**NEW YORK STATE THRUWAY AUTHORITY
DEPARTMENT OF ENGINEERING**

**AMENDMENT NO. 1
TO**

**CONTRACT TAA 25-21B
D215044
REPLACEMENT OF THE INTERCHANGE 21
BRIDGE OVER NYS THRUWAY (I-87)
AT MP 113.89
IN THE ALBANY DIVISION
OF THE NEW YORK STATE THRUWAY
IN GREENE COUNTY**

**IN THE LETTING OF
OCTOBER 15, 2025**

TITLE OF PROJECT BRIDGE REPLACEMENT INTERCHANGE 21	CONTRACT NUMBER: TAA 25-21B
LOCATION OF PROJECT ALBANY DIVISION MP 113.89	DATE: 08/26/2025
TITLE OF DRAWING SIGNAGE AND PAVEMENT MARKING PLANS (SHEET 1 OF 3)	DRAWING NUMBER: SPM-01

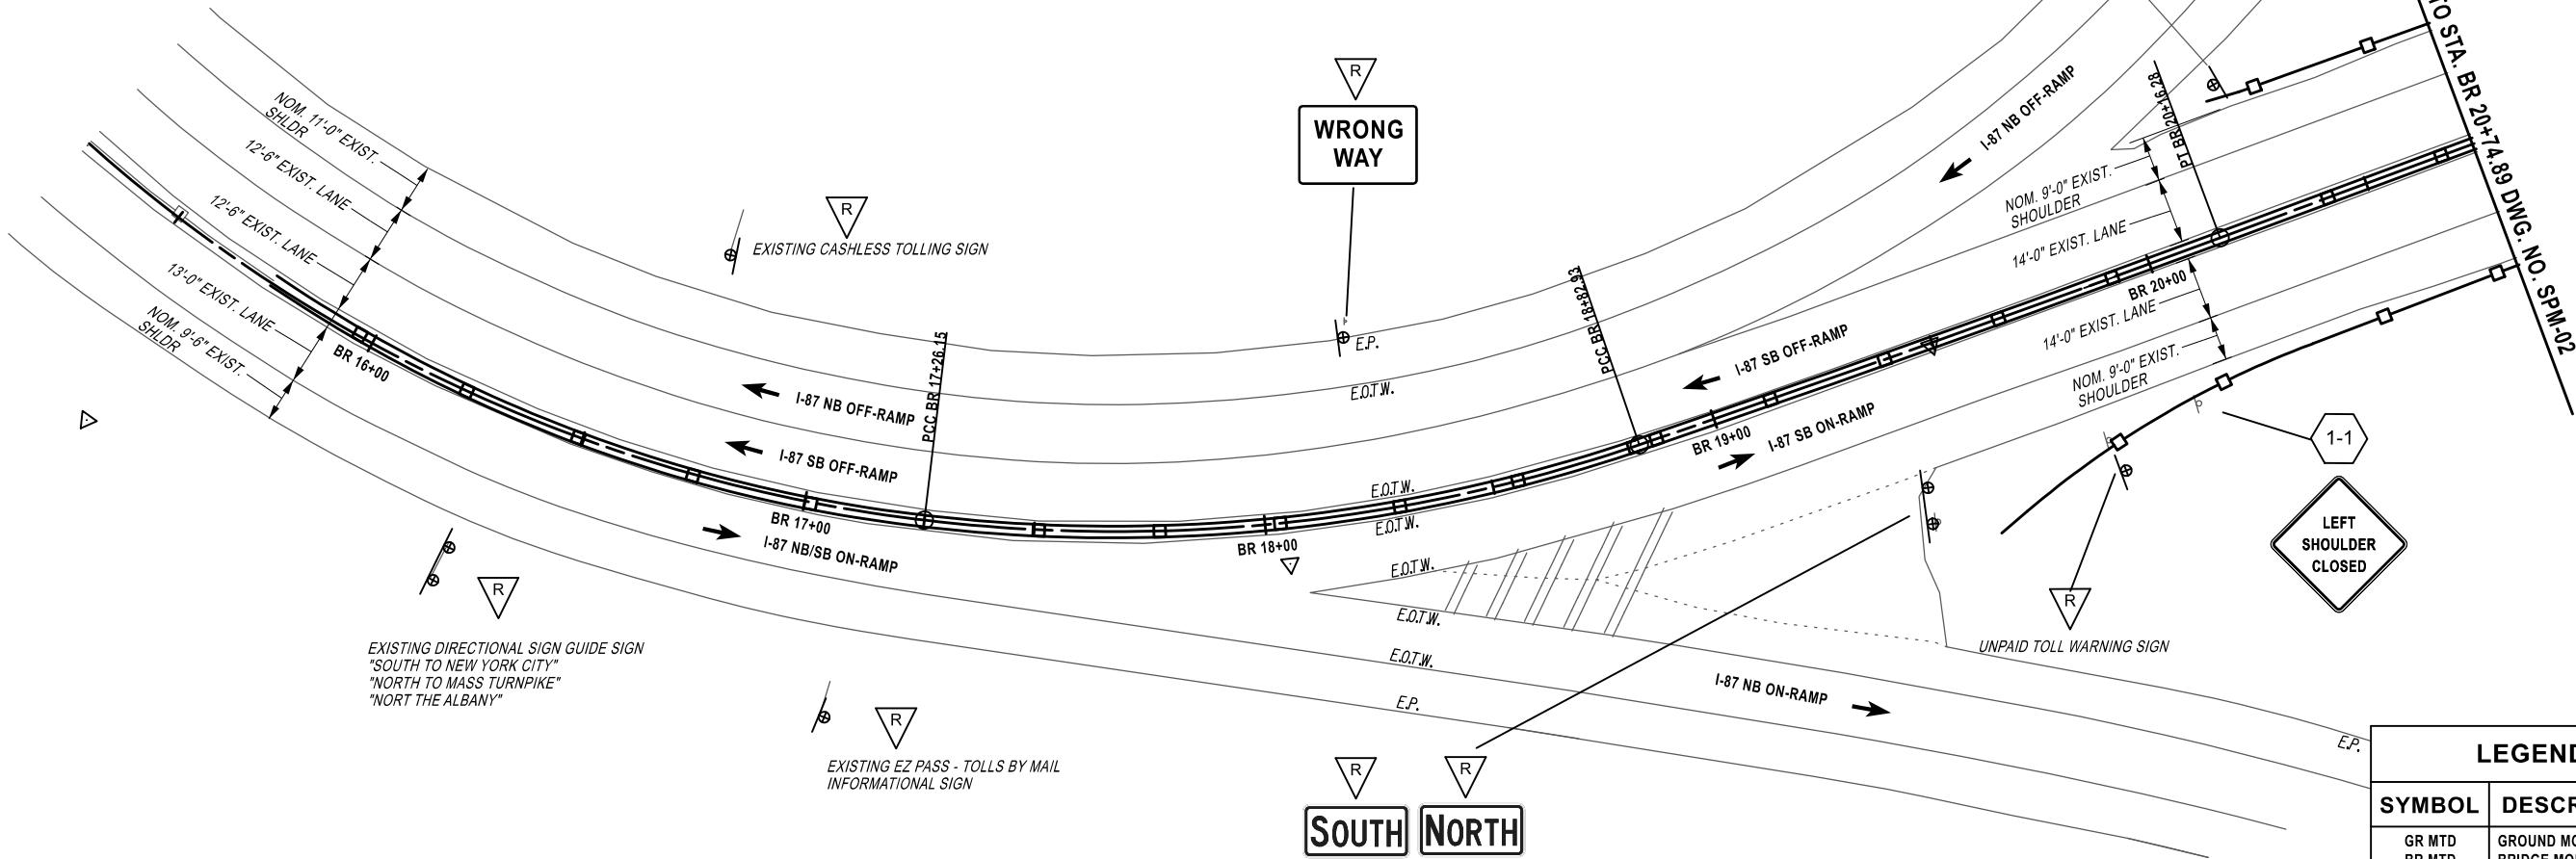
3. **DELETE** Drawing Number SPM-01, Sheet 47 of 118 and **SUBSTITUTE** with the attached Drawing Number SPM-01, Sheet 47-A1 of 118. A new Note 2. has been added regarding work to be paid for under Item 647.51. The Legend has also been updated.

TITLE OF PROJECT BRIDGE REPLACEMENT INTERCHANGE 21		CONTRACT NUMBER: TAA 25-21B	
LOCATION OF PROJECT ALBANY DIVISION MP 113.89		DATE: 08/26/2025	
TITLE OF DRAWING SIGNAGE AND PAVEMENT MARKING PLANS (SHEET 2 OF 3)		DRAWING NUMBER: SPM-02

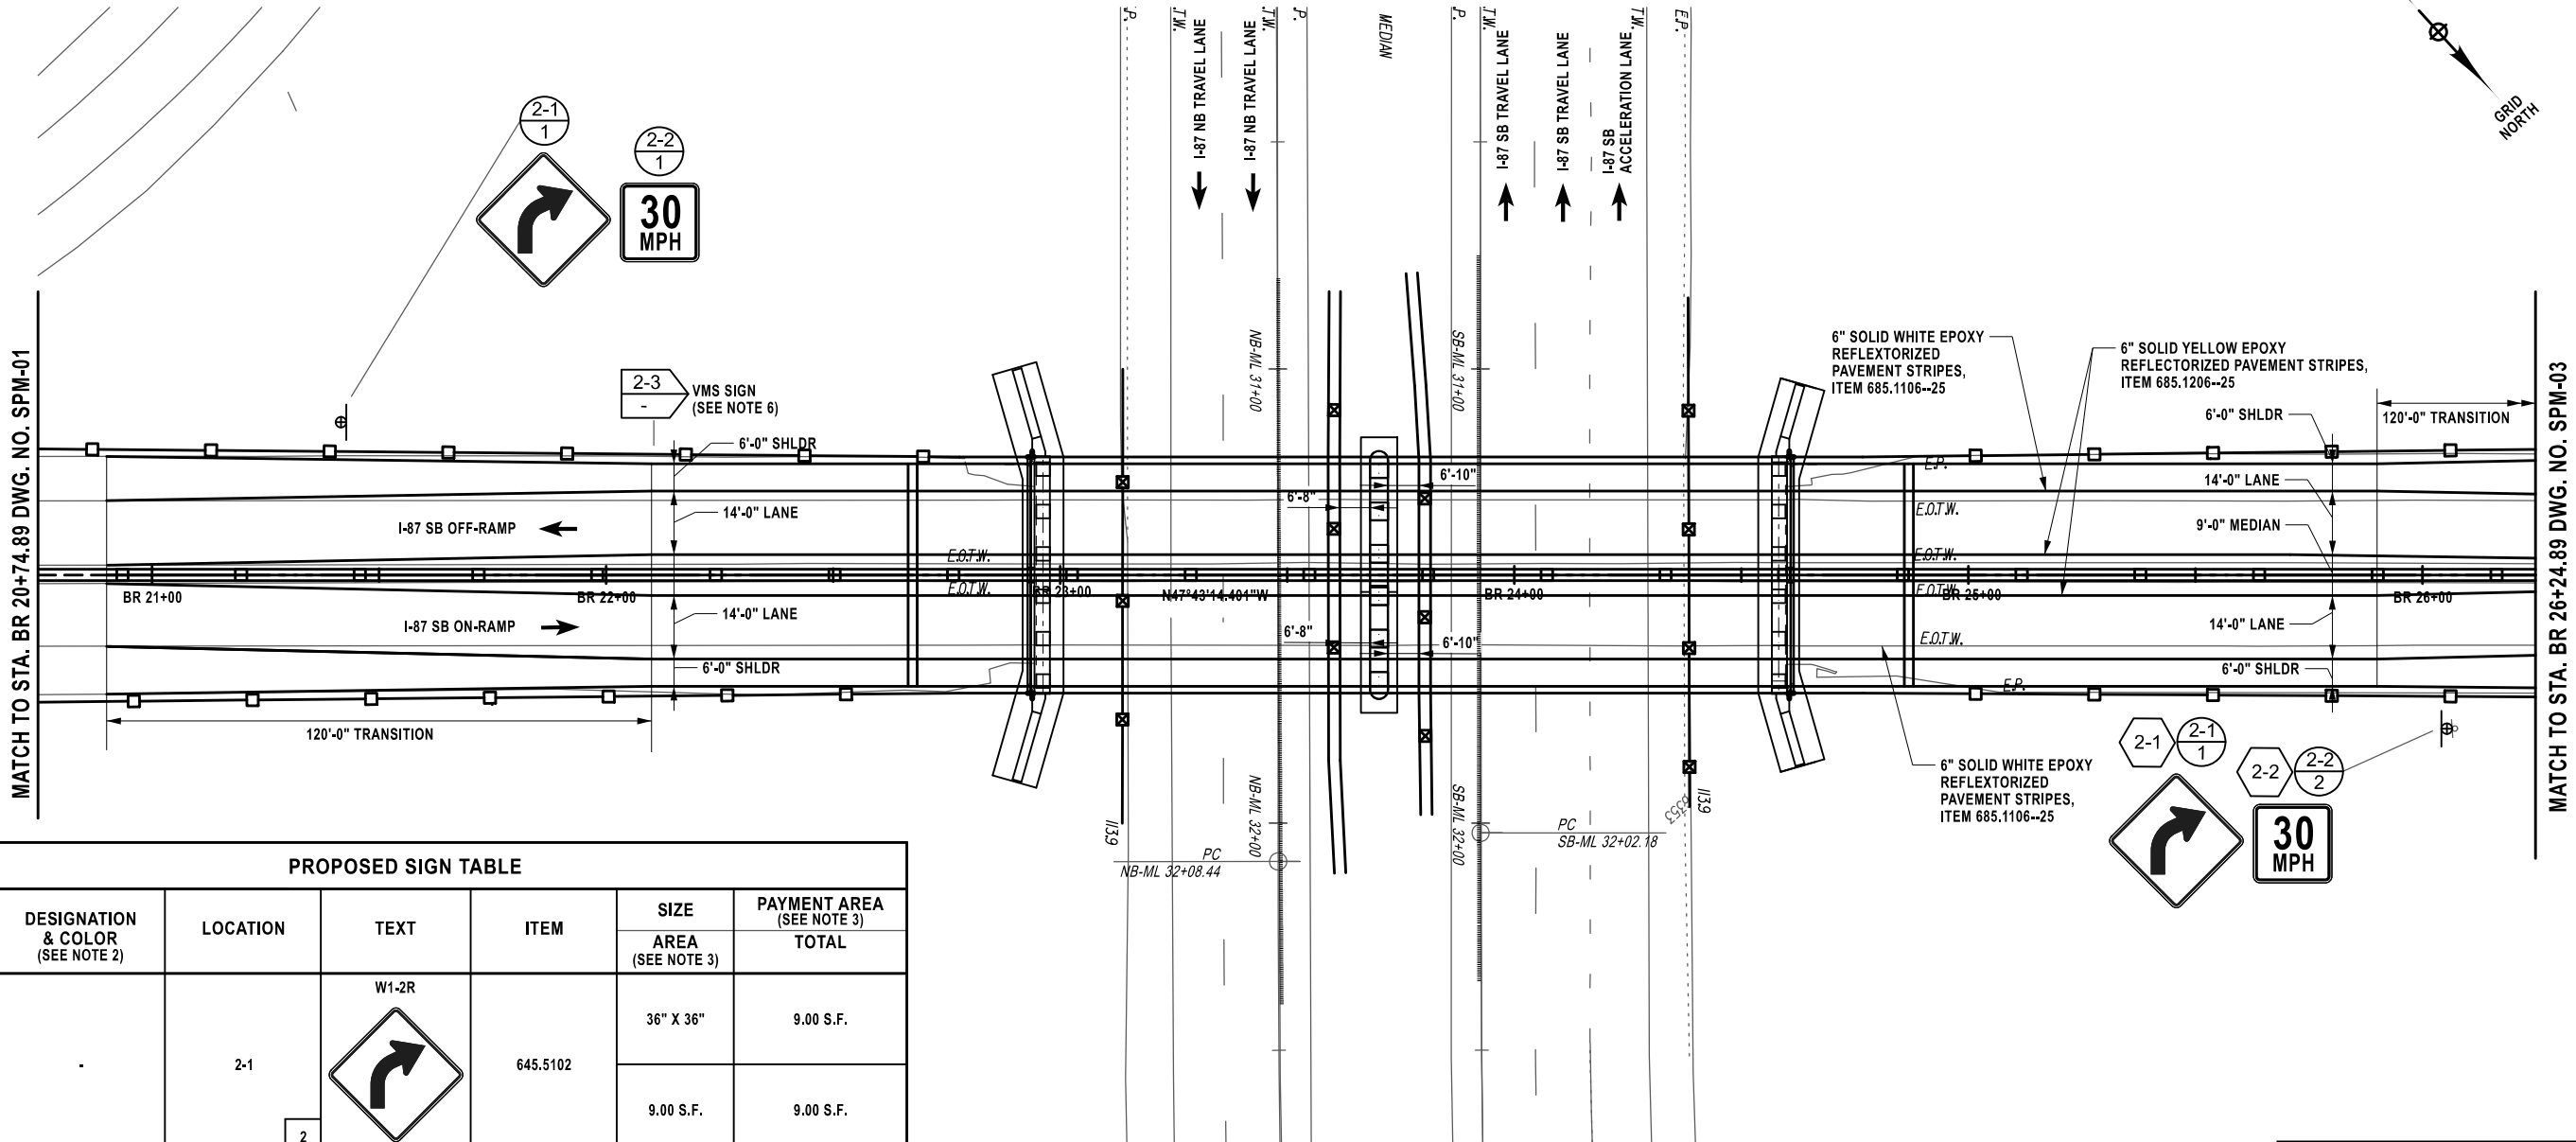
4. **DELETE** Drawing Number SPM-02, Sheet 48 of 118 and **SUBSTITUTE** with the attached Drawing Number SPM-02, Sheet 48-A1 of 118. A new Note 5 regarding the work to be paid for under Item 647.51 has been added and Note 6 regarding ITS related work has been added. The Legend has also been updated.

TITLE OF PROJECT BRIDGE REPLACEMENT INTERCHANGE 21	CONTRACT NUMBER: TAA 25-21B
LOCATION OF PROJECT ALBANY DIVISION MP 113.89	DATE: 08/26/2025
TITLE OF DRAWING SIGNAGE AND PAVEMENT MARKING PLANS (SHEET 3 OF 3)	DRAWING NUMBER: SPM-03

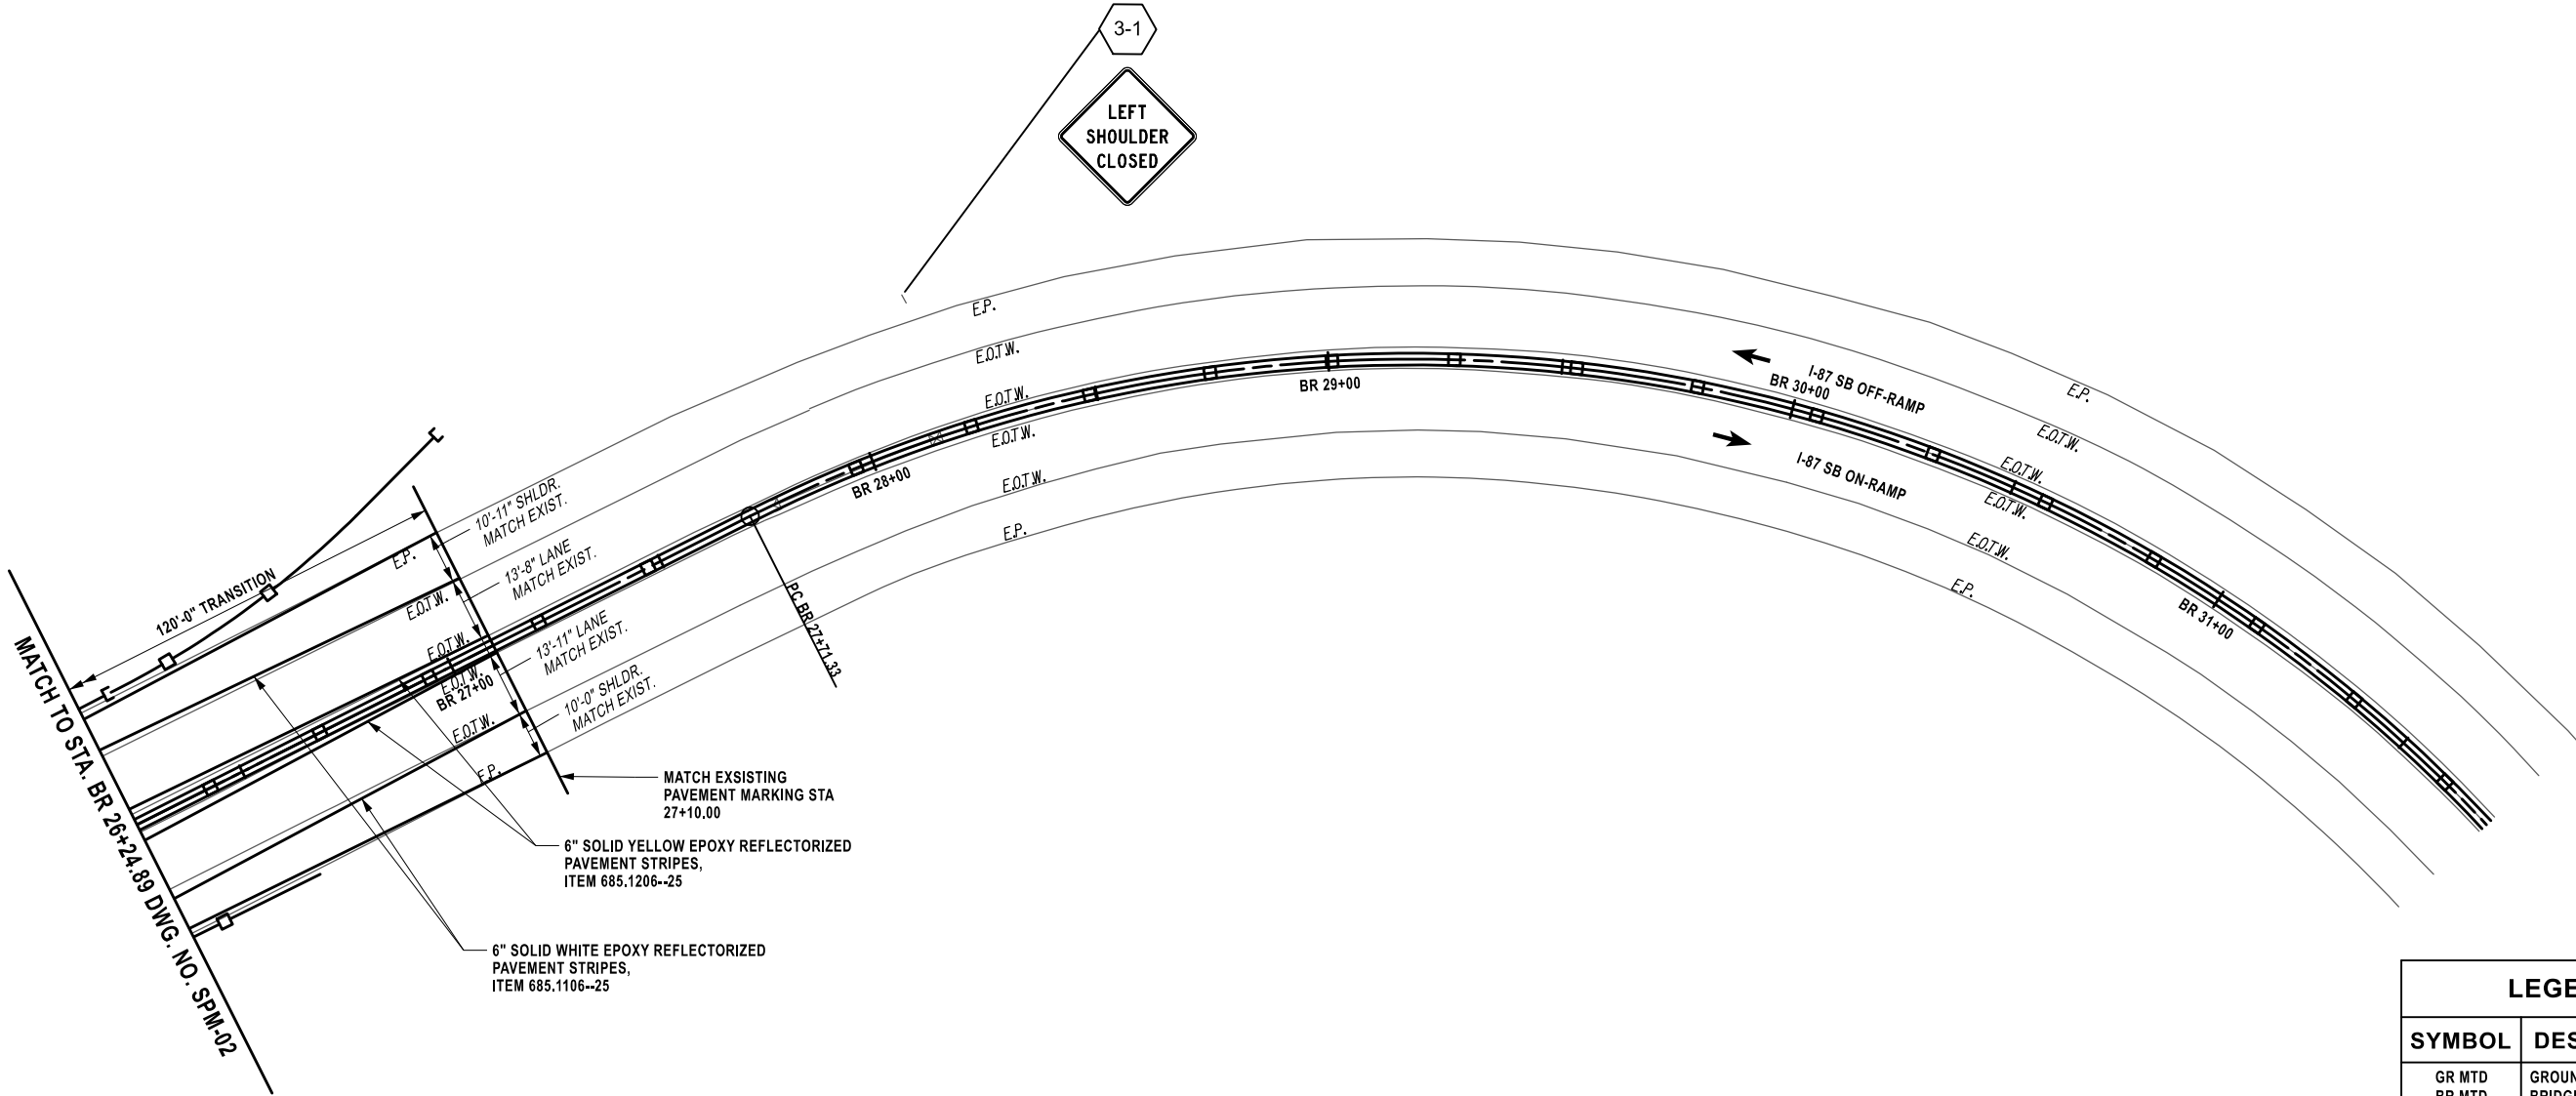
5. **DELETE** Drawing Number SPM-03, Sheet 49 of 118 and **SUBSTITUTE** with the attached Drawing Number SPM-03, Sheet 49-A1 of 118. Two new notes have been added. One note is to refer to another plan sheet for applicable notes, and the other note is regarding work to be paid for under Item 647.51. The Legend has also been updated.

TITLE OF PROJECT: BRIDGE REPLACEMENT INTERCHANGE 21	CONTRACT NUMBER: TAA 25-21B
LOCATION OF PROJECT: ALBANY DIVISION MP 113.89	DATE: 08/26/2025
TITLE OF DRAWING: DECK REINFORCEMENT PLAN	DRAWING NUMBER: ST-42

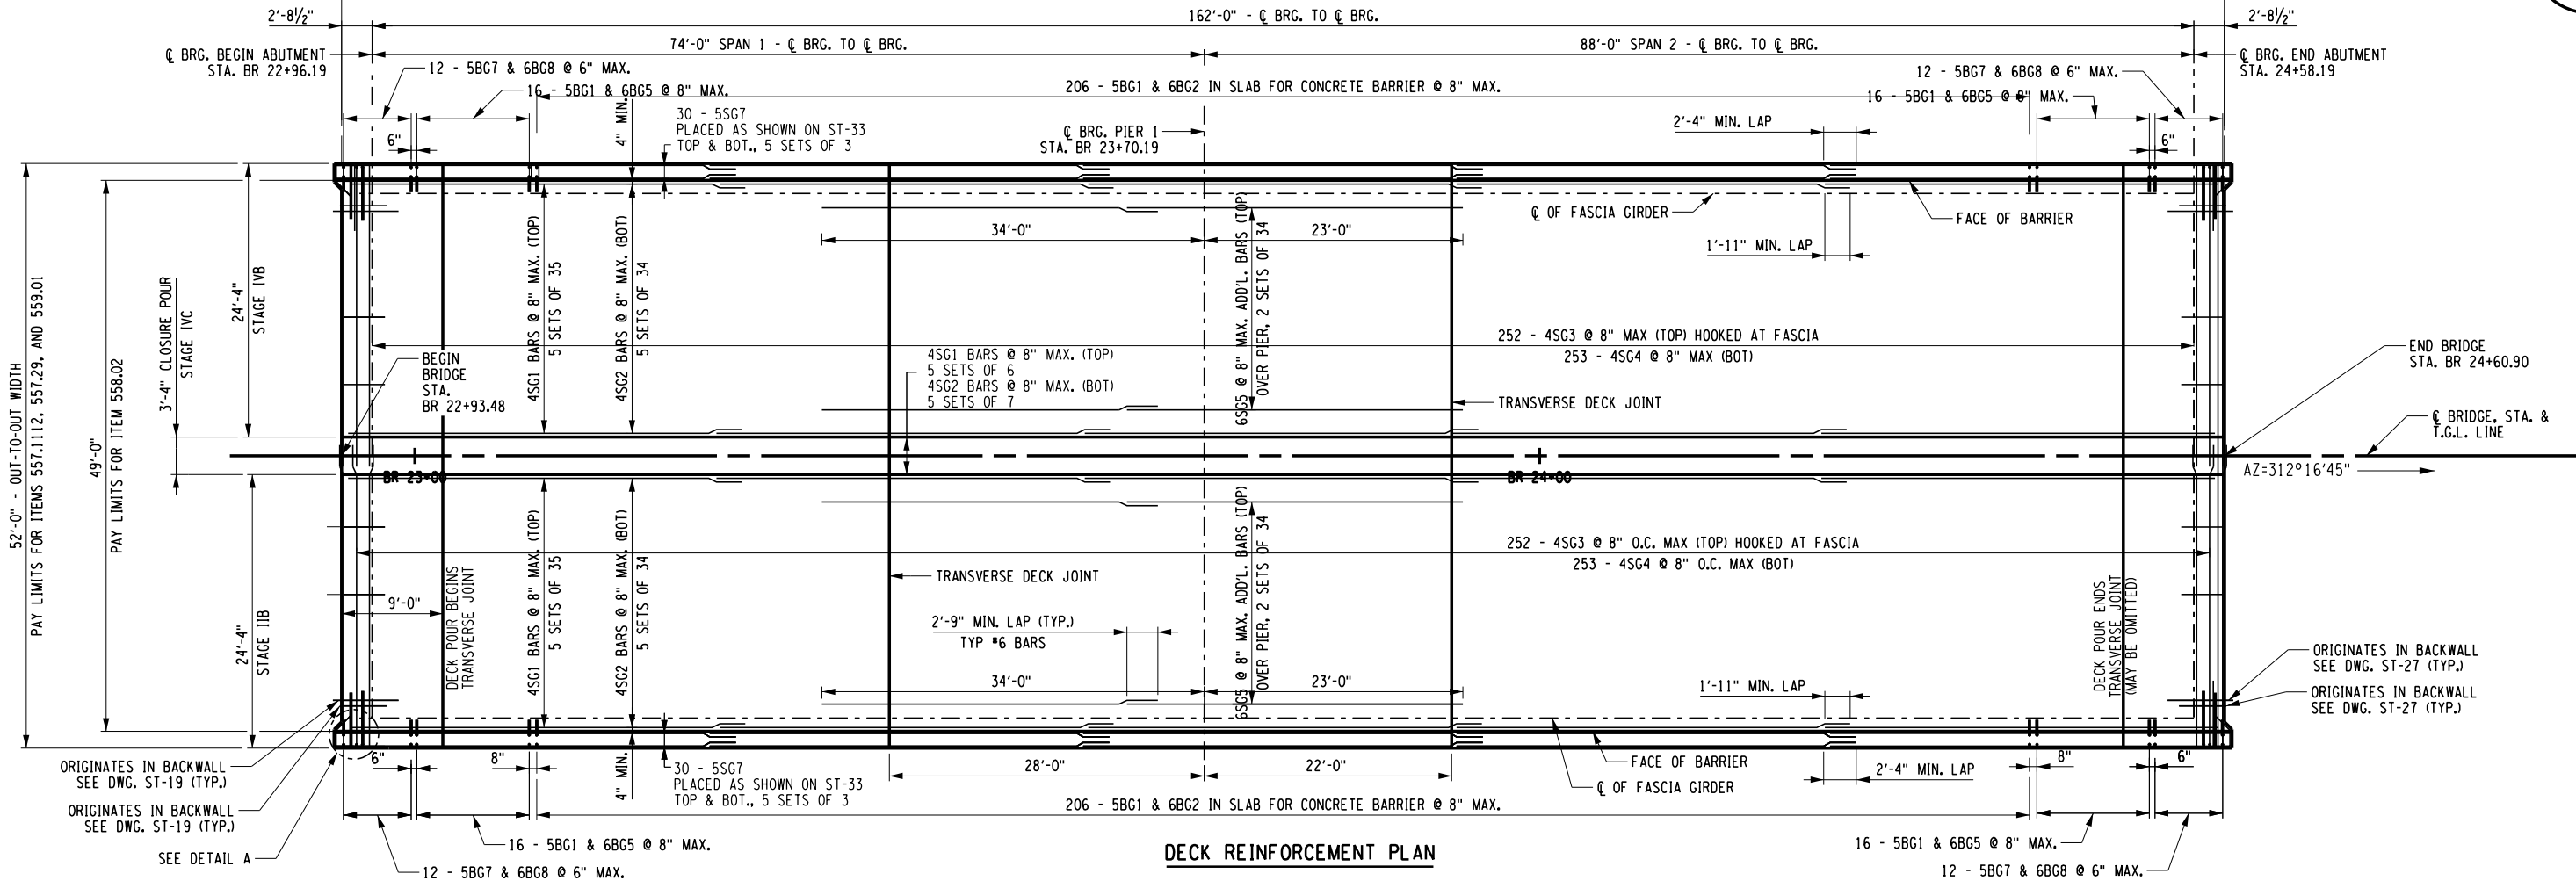
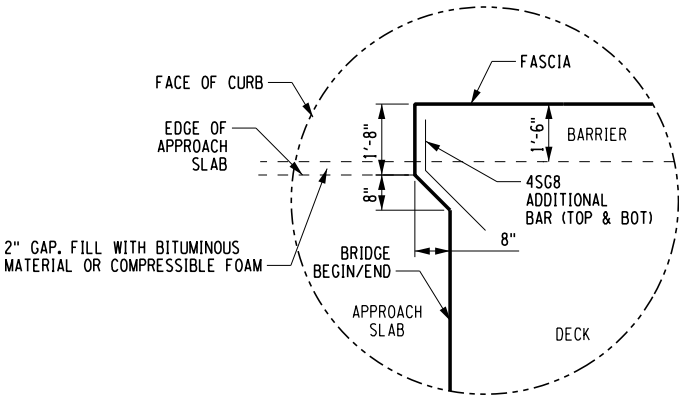
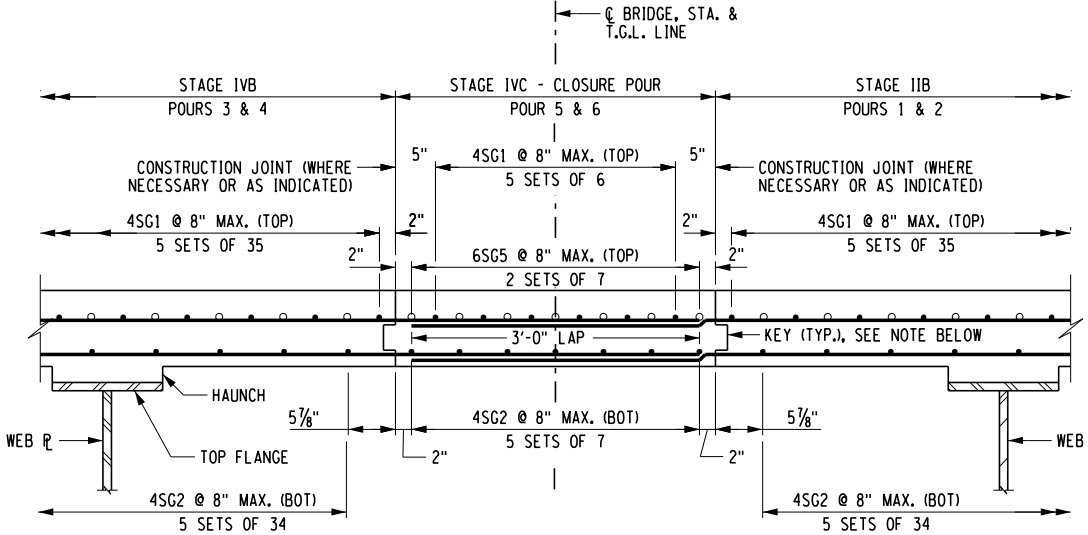
6. **DELETE** Drawing Number ST-42, Sheet 100 of 118 and **SUBSTITUTE** with the attached Drawing Number ST-42, Sheet 100-A1 of 118. The number of 4SG3 (top) bars and 4SG4 (bottom) bars as shown on the right side of the Deck Reinforcement Plan detail has been updated.
